Subject: AP1000 Response to Requests for Additional Information (SRP3.9.5)

Response to Requests for Additional Information on SRP Section 3.9.5

RAI Response Number: RAI-SRP3.9.5-EMB1-01
Revision: 0

Figure 1 – Flow Skirt ASME Code Jurisdictional Boundaries

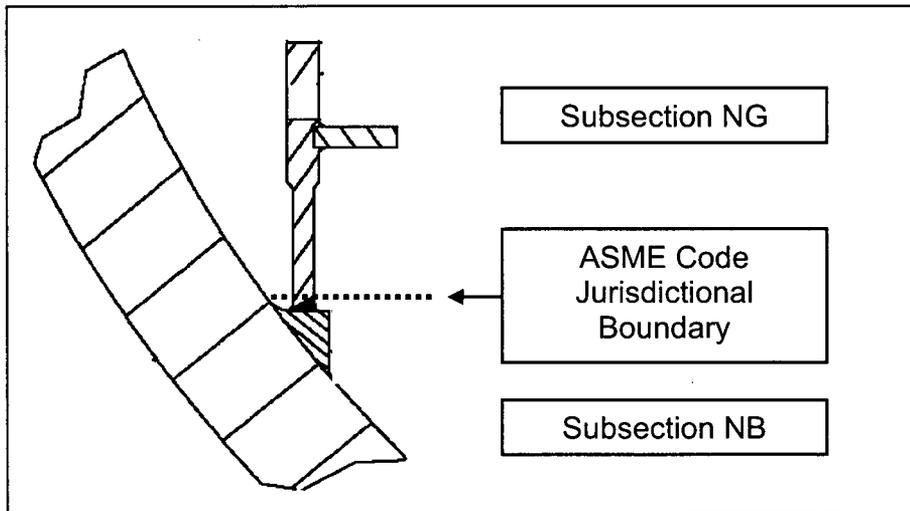
- In accordance with ASME III, Subsection NG-1120, is the flow skirt classified as a core support structure or as an internal structure?
- If classified as an internal structure, what design criteria are specified as the basis for design and construction of the flow skirt?
- Explain how flow-induced vibratory loadings have been incorporated in the design of the flow skirt.
- Is a stress report or design report summary available to document the design stress margins for the flow skirt?

a. Following the requirements in ASME Section III Article NB-1132.1(a), NB-1132.1(b)(2)(b), and NB-1132.1(c)(1)(b), the AP1000 flow skirt is classified as a permanent, non-pressure-retaining structural attachment to the reactor vessel.

Consistent with Article NB-1132.2(d), the jurisdictional boundary between the reactor vessel and the flow skirt is the first attachment weld; specifically, the flow skirt to flow skirt support lug. The attachment weld is analyzed to NB-3200 as part of the reactor vessel as shown in Figure 1 below.

Figure 1 – Flow Skirt Isometric View

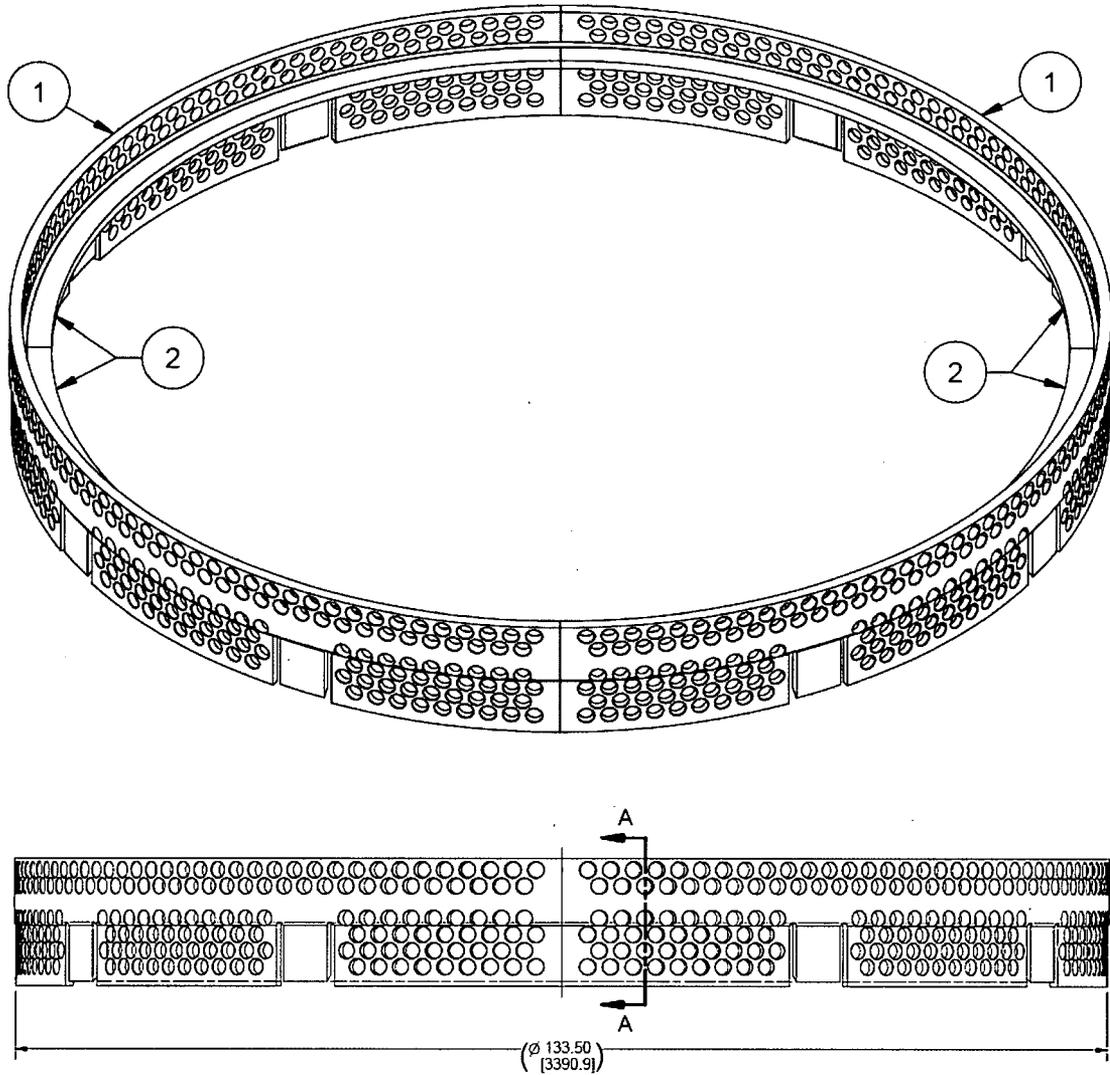
DCD Fig. 3.9-8 illustrates the flow skirt as a solid beam-like structure which is not representative of either its function or its description. Further clarification of Fig. 3.9-8, or additional figure details, should be provided to facilitate understanding of the form and function of this newly added component.

The flow skirt is a perforated cylindrical structure with a horizontal stiffening flange that is supported by eight lugs inside the reactor vessel lower head. Please see the attached Figures 1 and 2, which illustrate the flow skirt.
